Application EPR/RP3133LD/V014 Response to Schedule 5

Aberthaw Power Station EP RP3133LD

Reference Number: RP3133LD/V014/Sch5

Response to Schedule 5

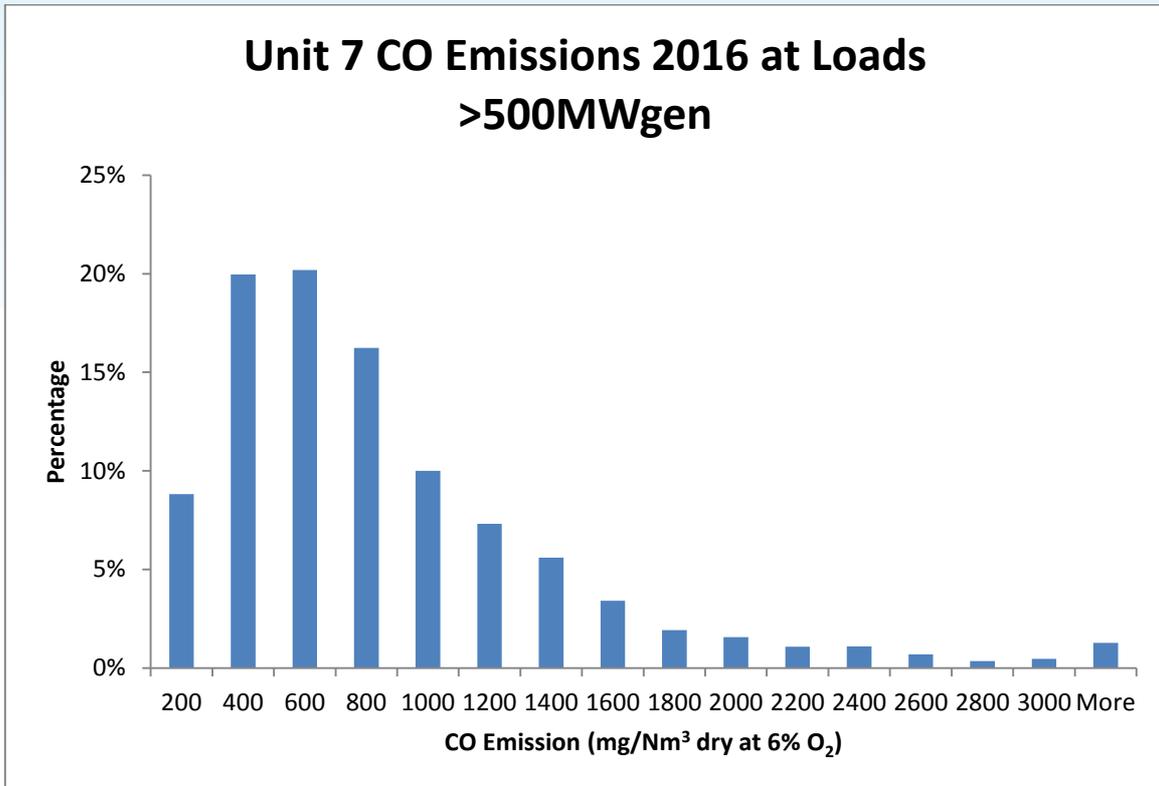
E) Page 5 of the ASD states that:

“the proportion of NO:NO₂ is expected to remain similar”.

Please explain whether the NO:NO₂ ratio will be reconfirmed by measurement during commissioning of each upgrade unit?

During commissioning total NO_x (NO & NO₂) will be measured using a Horiba gas analyser at the FGD inlet. This will be compared to the unit's stack NO_x emission to determine if the ratio of NO to NO₂ has changed. ASTs are planned on each of the units in 2017 in addition to QAL2s in 2018 following commissioning of the units on HVMC.

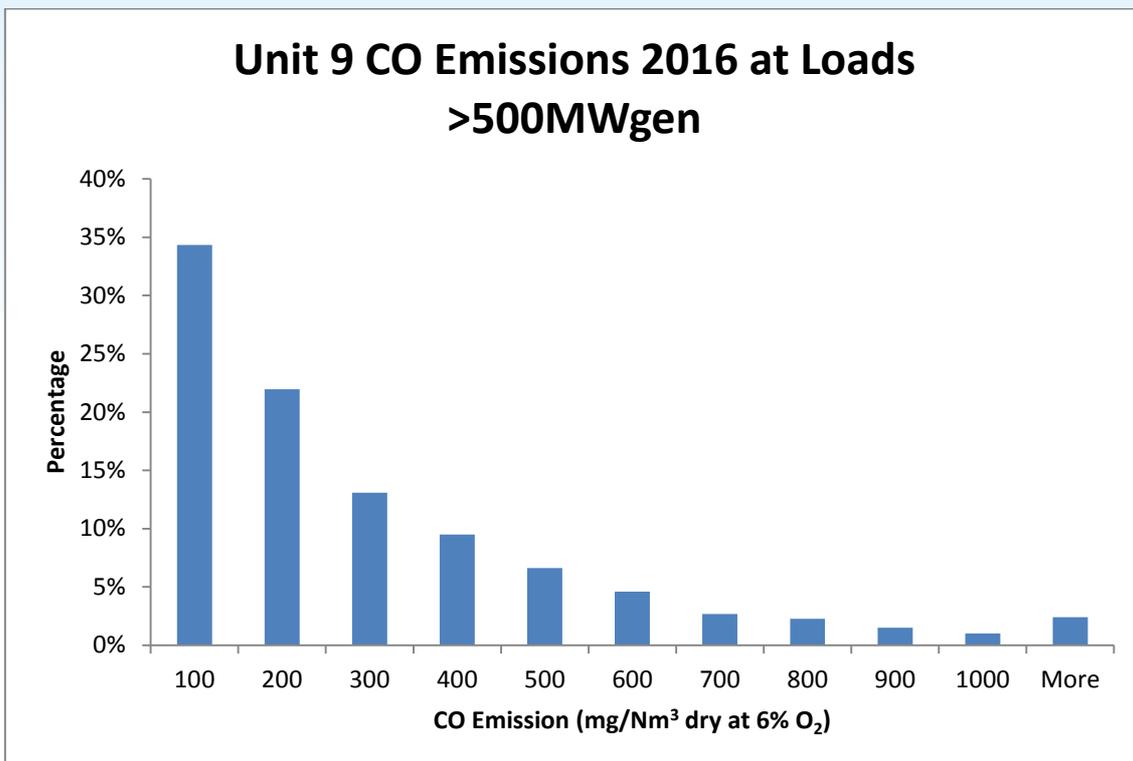
G) Page 7 of the ASD states that no significant change in carbon monoxide emissions is expected from the change to HVMCs. Please provide data from current operation and the HVMC firing trials to demonstrate that CO emissions will remain comparable to current levels.

Current Operating performance on Unit 7:-

CO during the Unit 7 HVMC trial was 1600mg/Nm³ dry at 6% O₂ between 14:00 and 16:00 on the 8th of March 2016 when the unit was operated on 5 mills of Kedrovsky and one mill of Tower

Current Operating performance on Unit 9:-

CO during the Unit 9 HVMC trial was 160mg/Nm³ dry at 6% O₂ between 12:00 and 16:00 on the 23rd of June 2016 when Unit 9 was operated on 5 mills of Kedrovsky and one mill of Tower.

CO emissions were slightly higher on Units 7 and 9 during the Kedrovsky trials however the trial data is limited. CO emissions are not expected to be significantly higher on HVMC.

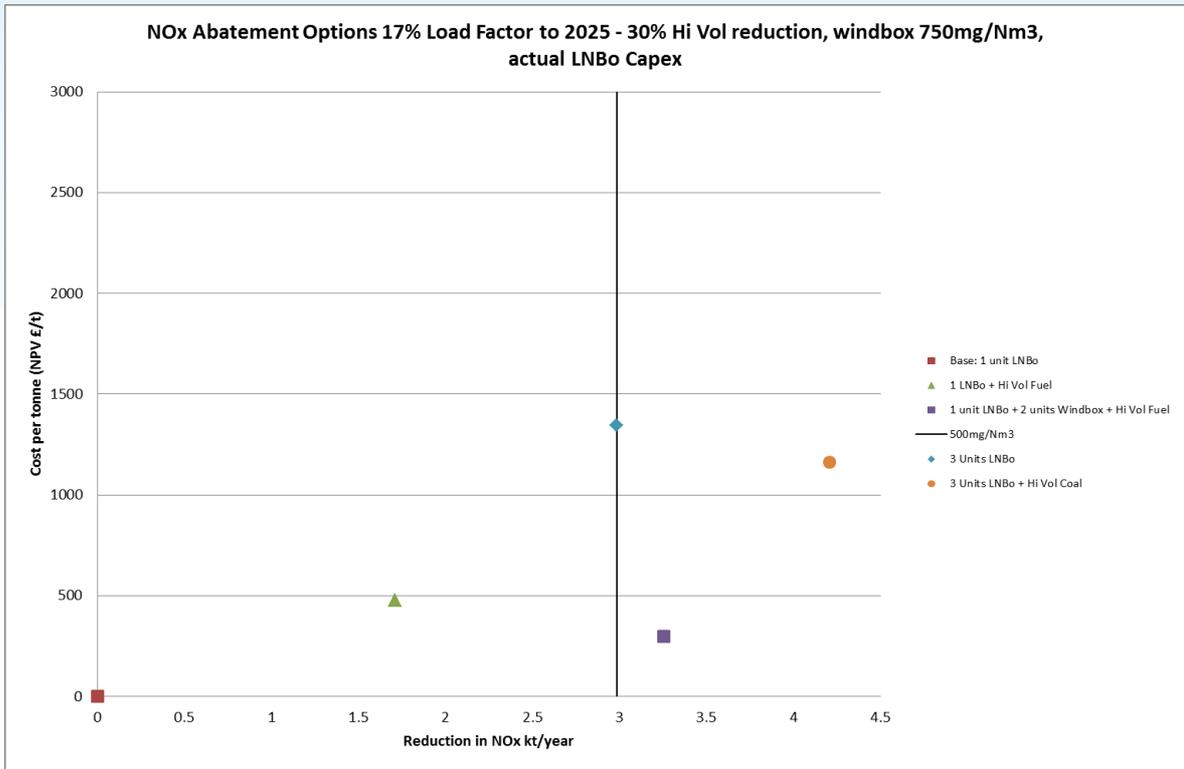
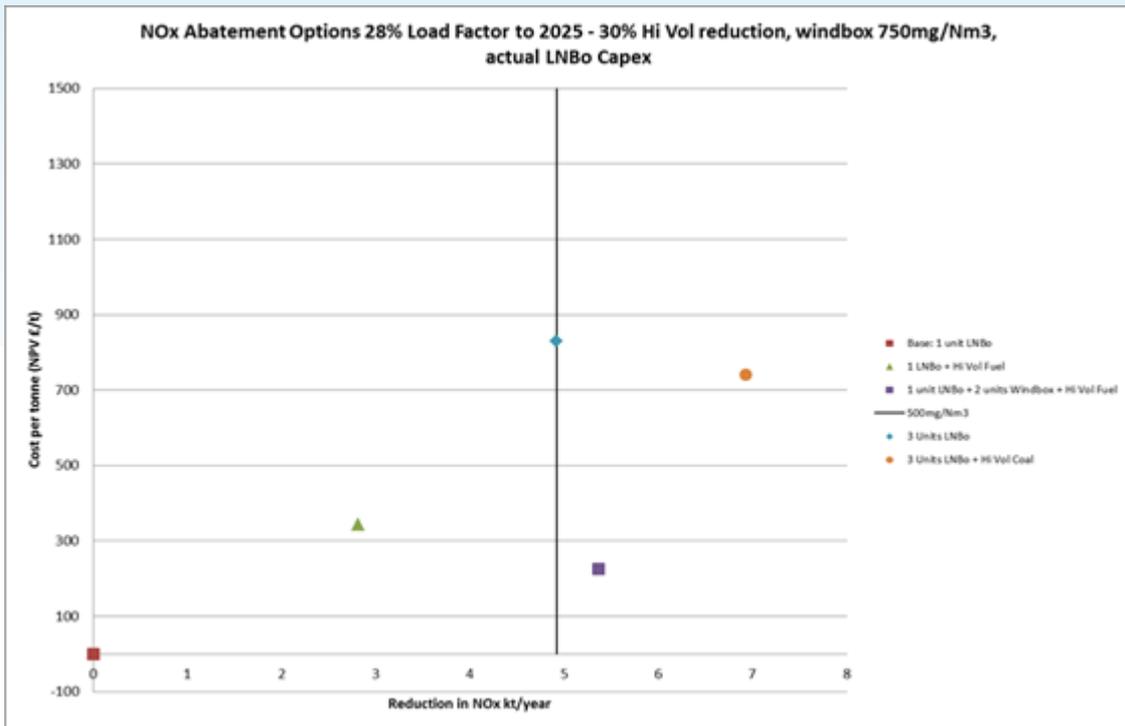
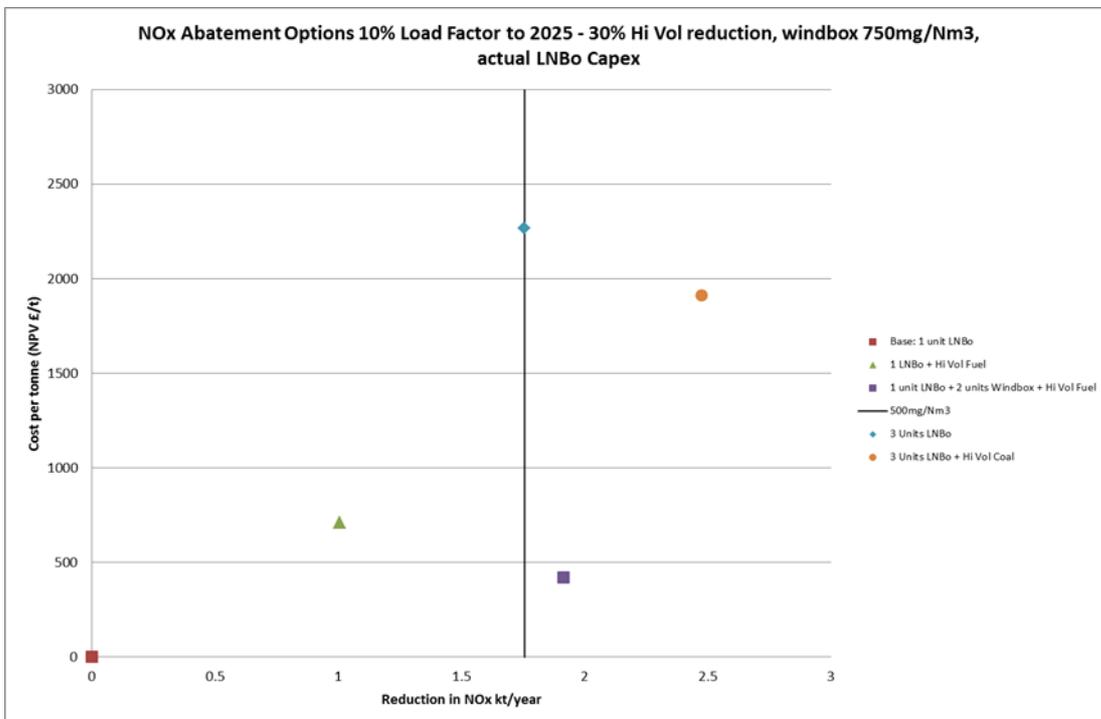
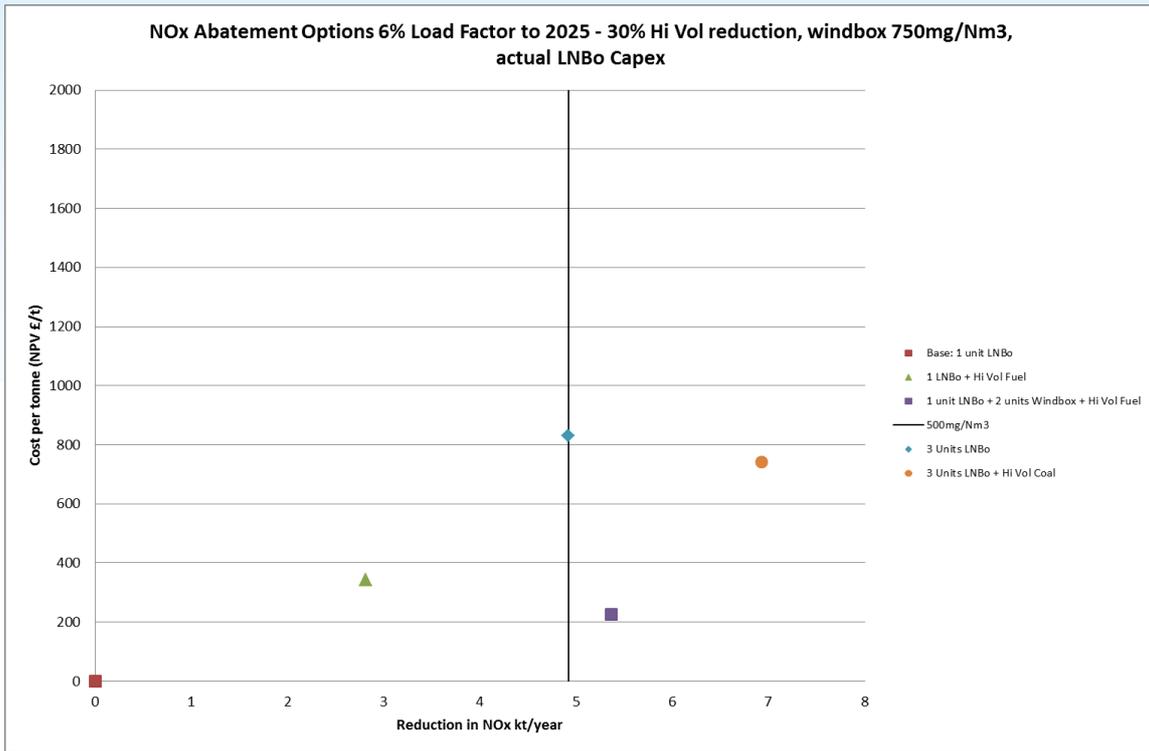
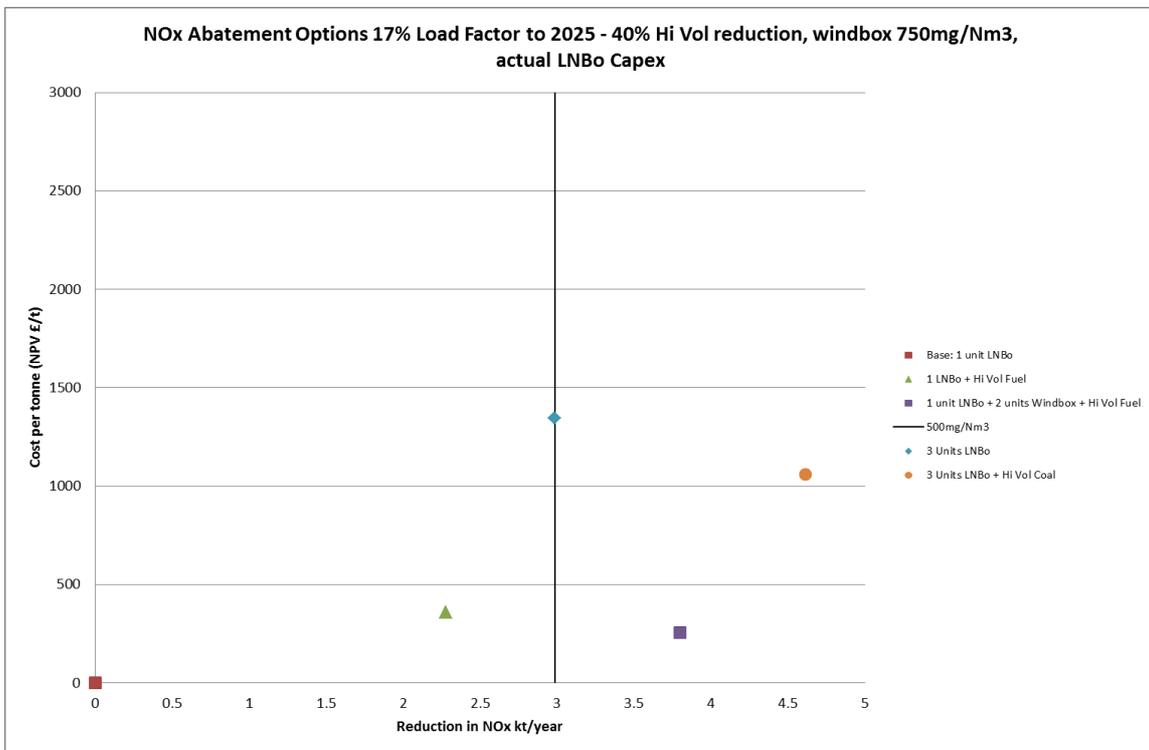
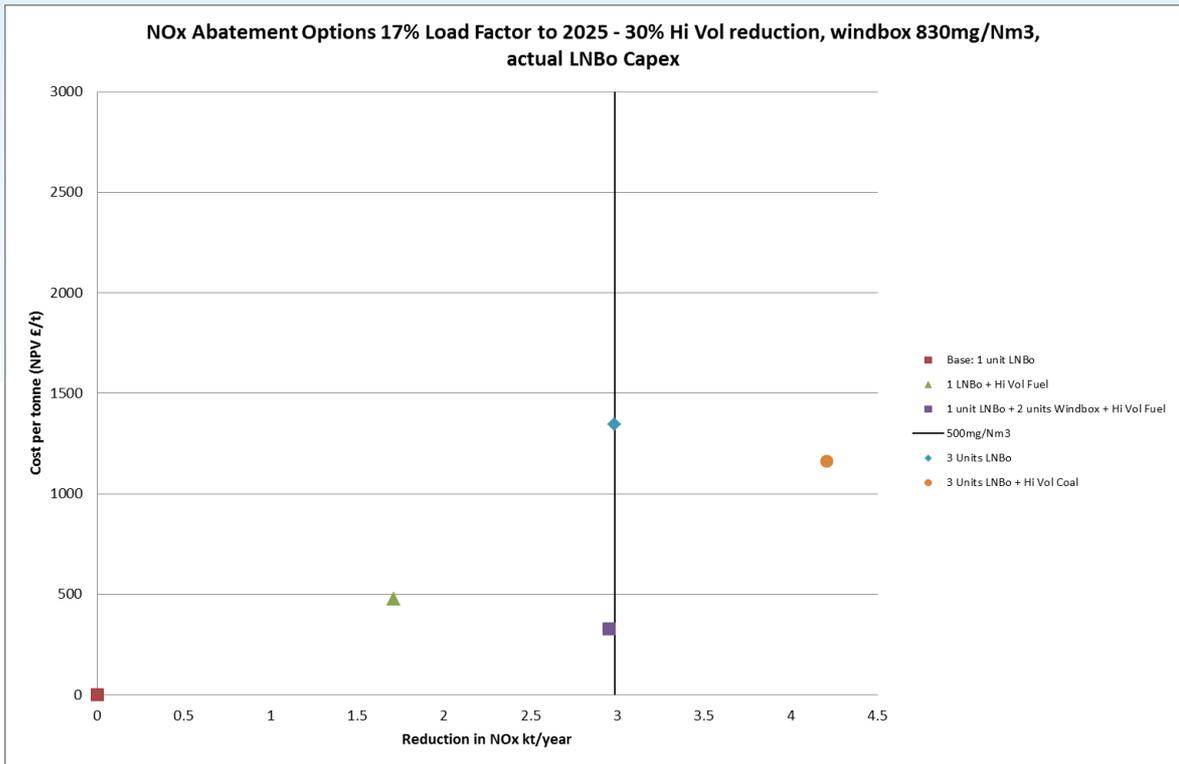
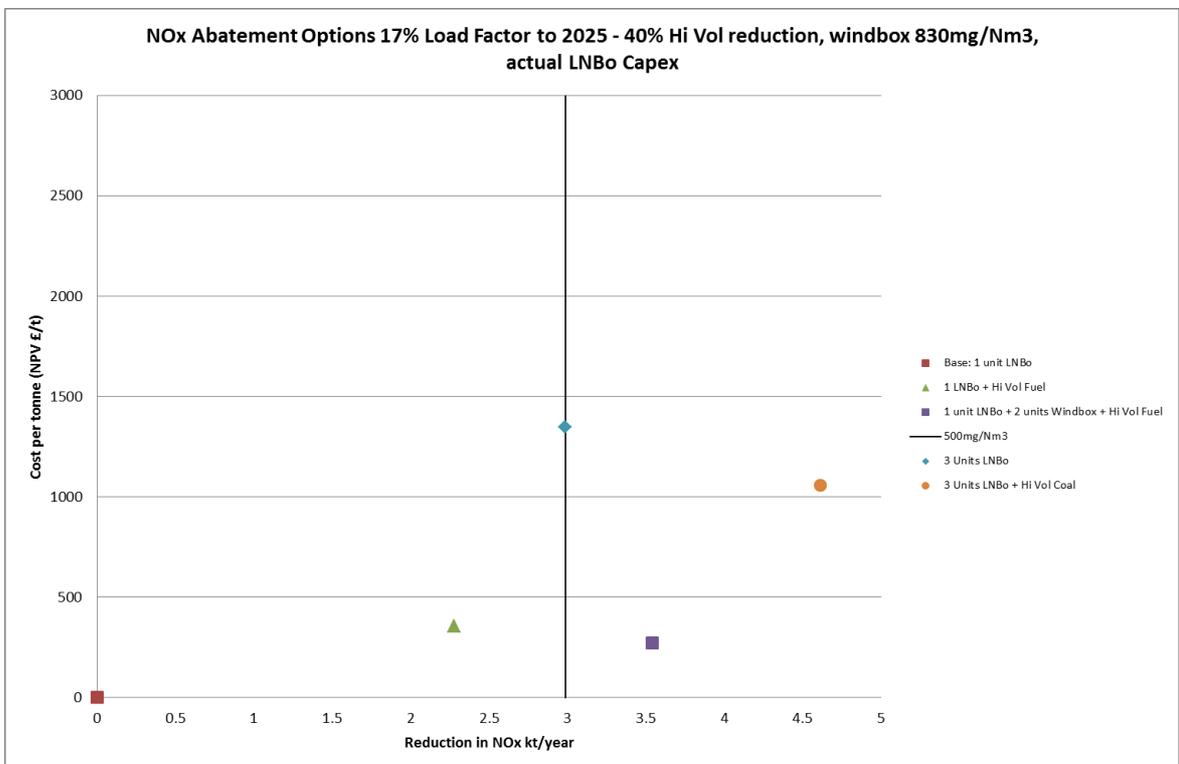
- M) Section 4 of the ASD provides a justification of the option choice for the installation in terms of plant modifications. Please provide a sensitivity analysis of the options appraisal outcome to key parameter assumptions, providing justifications where necessary, including the LNBo NO_x levels achieved <400 mg/m³, Opex, HVMC, air staging plates and load factor.

The methodology adopted for sensitivity study has been to vary one parameter at a time and calculate the emission and cost of abatement. The cost/tonne and annual emission are plotted for each option in the Appendix below.

Revised graphs can be seen in the Appendix to this document.

The costs per tonne of NOx abated and annual abatement vary with assumptions but overall the relative abatement and costs per tonne are similar for all the cases considered. The costs per tonne abated for the option with three LNBo units is sensitive, compared to the proposed 2 units of windbox modifications and switch to HVMC, to load factor. The base case assumption of 17% is the limit that will apply after 2020 and hence the low load factor cases may be more realistic assumptions than the high end case. With a high capital cost (£15.2 million) the cost per tonne abated for the all LNBo options are relatively sensitive to changes in load factor.

The base case assumption is that the windbox modification results in a NOx emission of 750mg Nm⁻³, using the low end of the predicted range of abatement (830mg Nm⁻³) with the base line (low) reduction from a switch to a HVMC diet the stack average concentration is 504mg Nm⁻³ which is slightly greater than 500mgNm⁻³ limit. However with the higher reduction from a coal change (40%) the stack average is well below the limit at 432mg Nm⁻³, the stack average is more sensitive to the coal abatement assumption than to the assumption of the abatement from the windbox modification.

The sensitivity study does not change the conclusion that the use of one unit LNBo with two units with windbox modifications and a switch to a high volatile coal diet is the lowest cost means of achieving the required stack gas NOx concentration. This is particularly true if the actual load factor at Aberthaw is less than the maximum permitted post 2020.

Graphs of the costs per tonne against reduction in NOx over the year can be found in the Appendix below.
